MEMORANDUM

TO: Douglas DeKoskie, New York City Department of Environmental Protection

FROM: James Murac, P. E., Milone & MacBroom, Inc.

RE: NYSDOT Options for Route 23 Bridge Replacement
Prattsville, New York
MMI #3597-19-2

DRAWING NAME:
FIG. 4

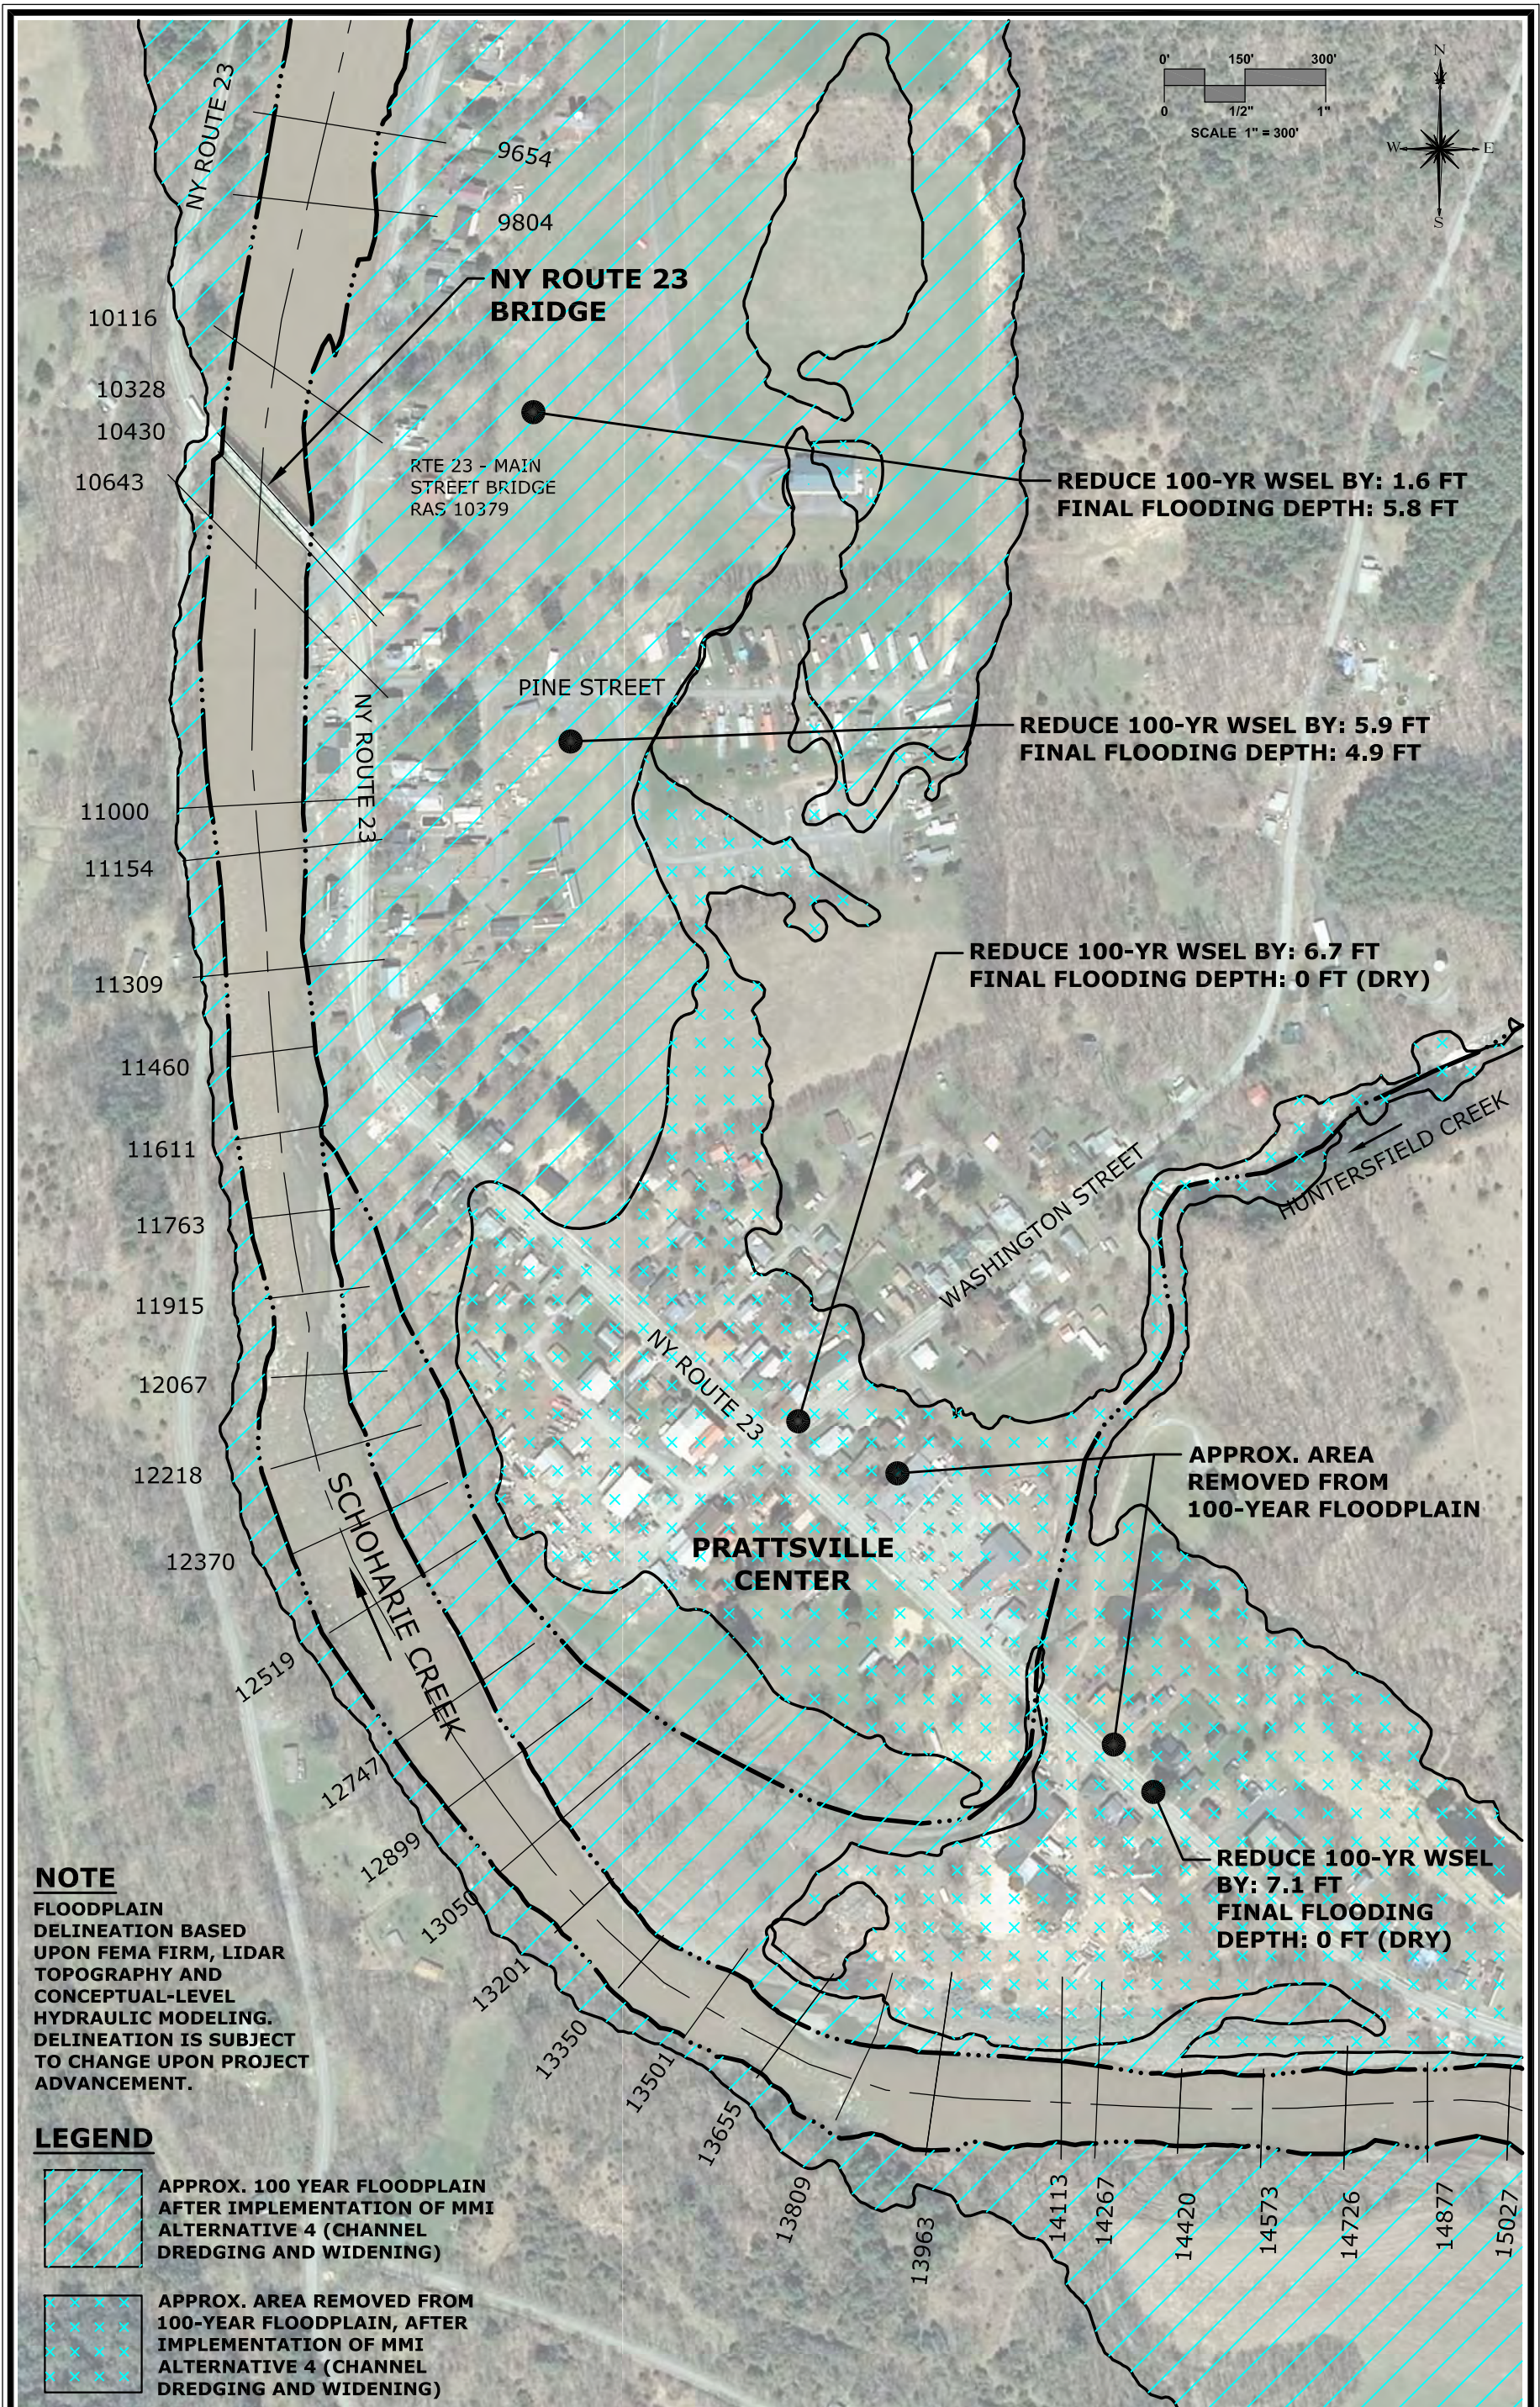
Figure 4 presents a graphic representation of the potential floodplain benefits of the hybrid alternative. Immediately adjacent to and upstream of the new crossing, water surface elevations during the 100-year event are predicted to decrease by 5.9 feet. Approximately 1,500 feet upstream, the majority of Prattsville Center would be removed from the 100-year floodplain entirely. Still further upstream, approximately 3,700 feet upstream of the bridge, water surface elevations are predicted to remove a large developed area upstream of Huntersfield Creek from the 100-year floodplain.

Referring back to Figure 4, a combination of bridge and channel improvements has the potential to reduce water surface elevations during the 100-year event by 5.9 feet near the bridge site and completely remove out of the 100-year floodplain a large portion of Prattsville Center as well as a large developed area upstream of Huntersfield Creek. Such potential flood mitigation is markedly greater than the NYSDOT Option 2 bridge, where a flood water reduction of only 1.5 feet is predicted in the vicinity of the bridge, and a reduction of only 0.7 feet is predicted near Prattsville Center.

DRAWING NAME:
FIG. 5

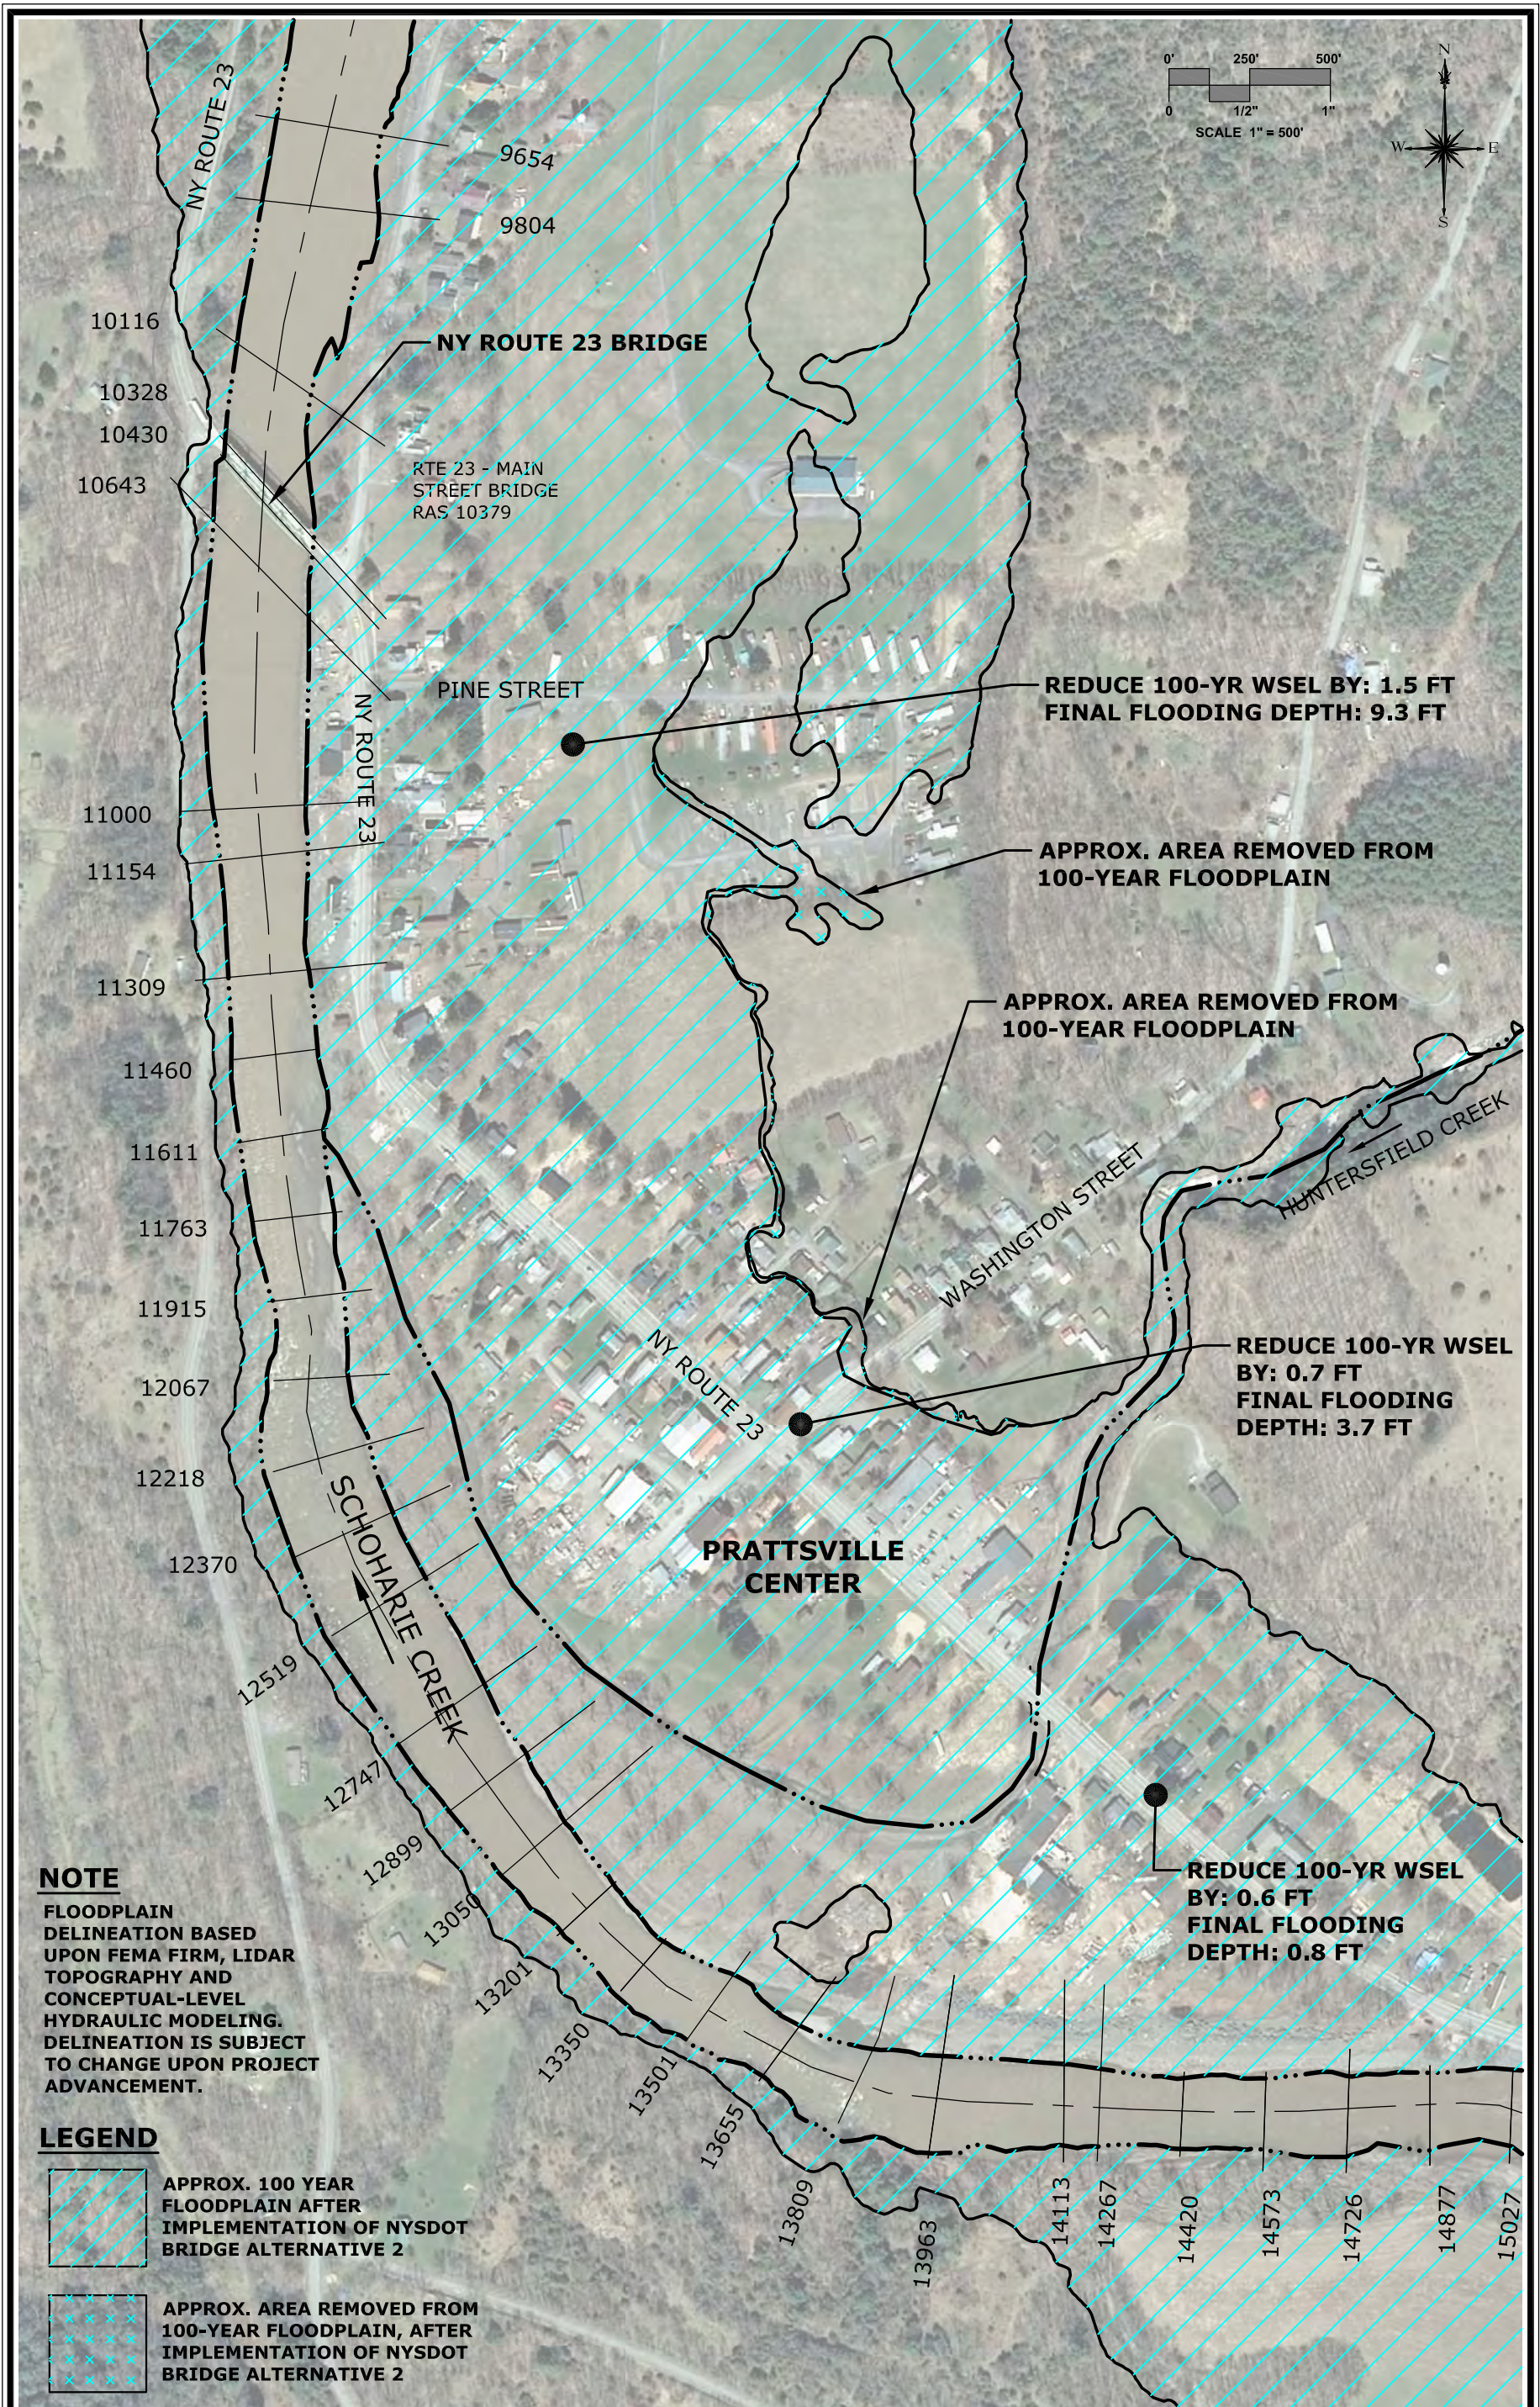
Figure 5 presents a graphic representation of the potential floodplain benefits of the NYSDOT Option 2 bridge. Immediately adjacent to and upstream of the new crossing, water surface elevations during the 100-year event are predicted to decrease by only 1.5 feet. Approximately 1,500 feet upstream, this benefit decreases to about 0.7 feet, leaving Prattsville Center under nearly 4 feet of floodwater during the 100-year event. Still further upstream, approximately 3,700 feet upstream of the bridge, water surface elevations are predicted to drop by only 0.6 feet, leaving a large developed area upstream of Huntersfield Creek in the active floodplain.

FIG. 6

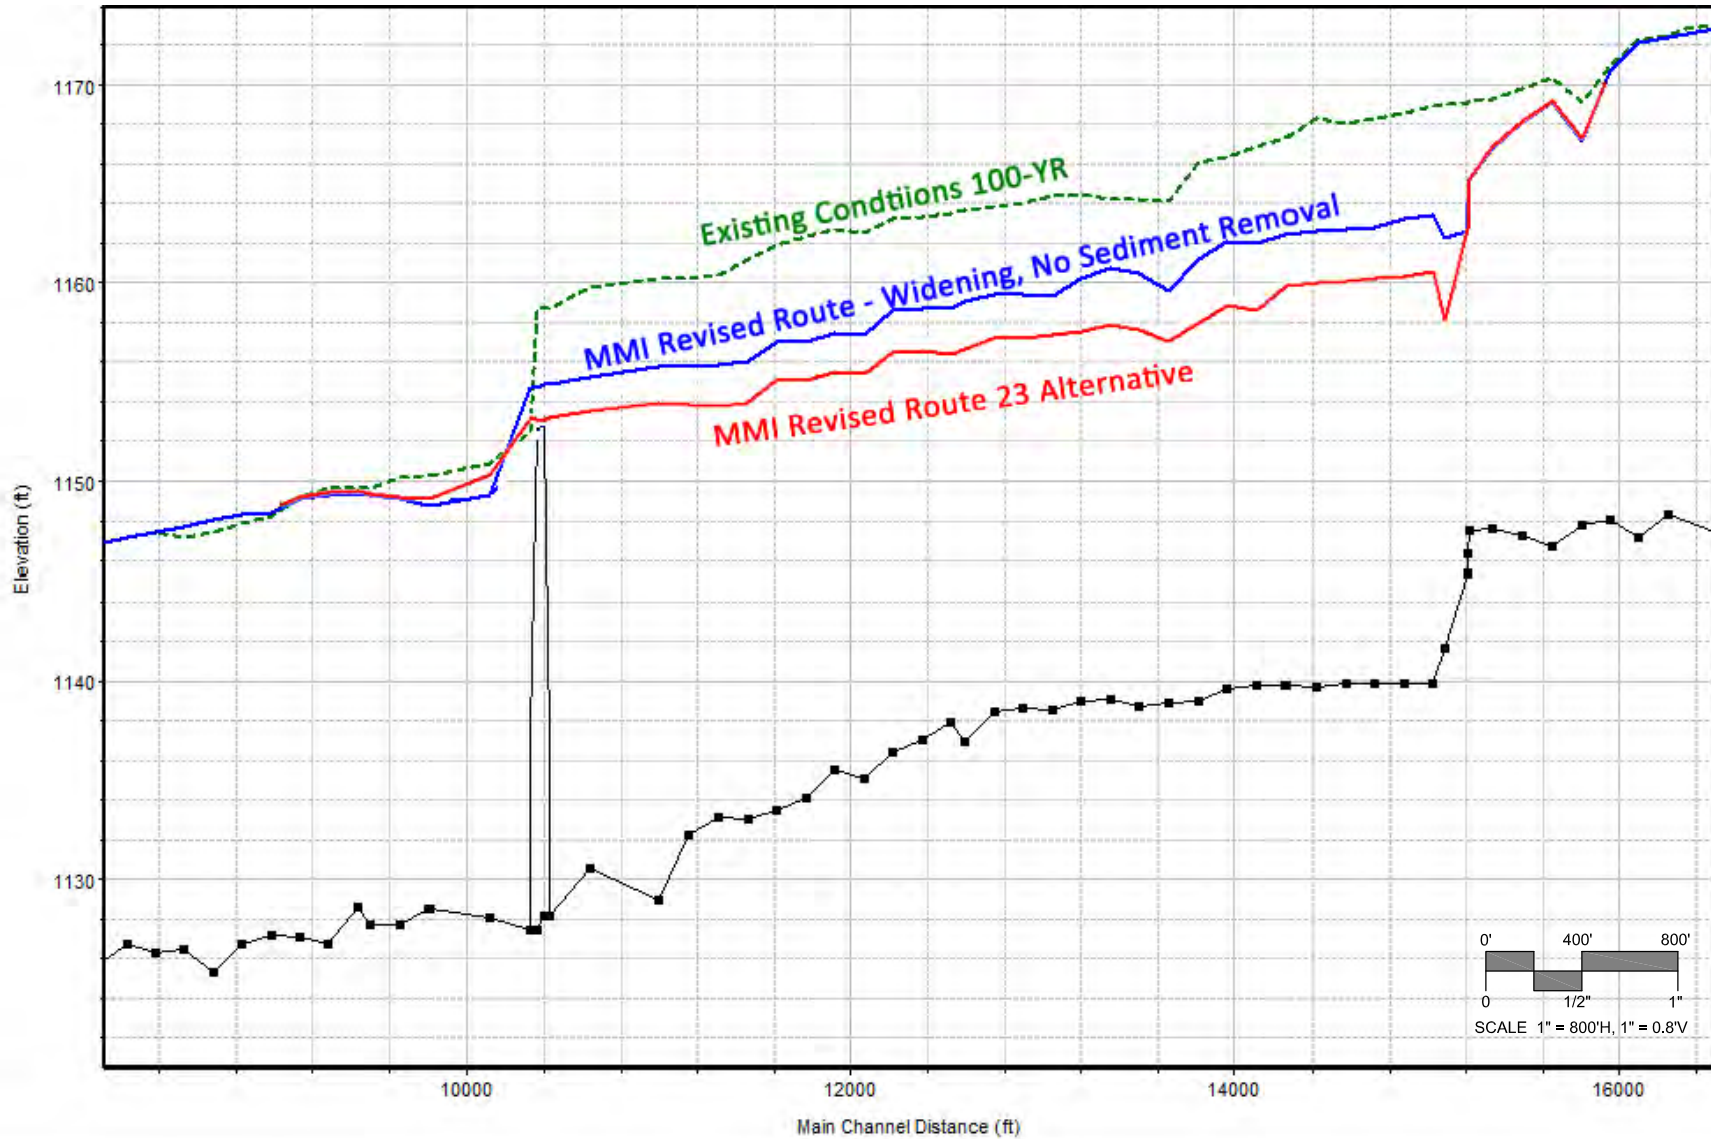
The proposed widening and reconstructed banks as depicted in Figure 3 have been modeled, and the hydraulic results of this hybrid alternative are presented in Figure 6, as well as in the appended cross sections. For the purposes of this evaluation, the bridge was modeled in the same horizontal position as the existing bridge, for easier comparison between the two. If pursued, the modeling would be updated to reflect actual conditions although this change is not expected to measurably modify the results. Figure 6 also presents the results of this bridge alternative if bed lowering/sediment removal was not possible or not sustainable.
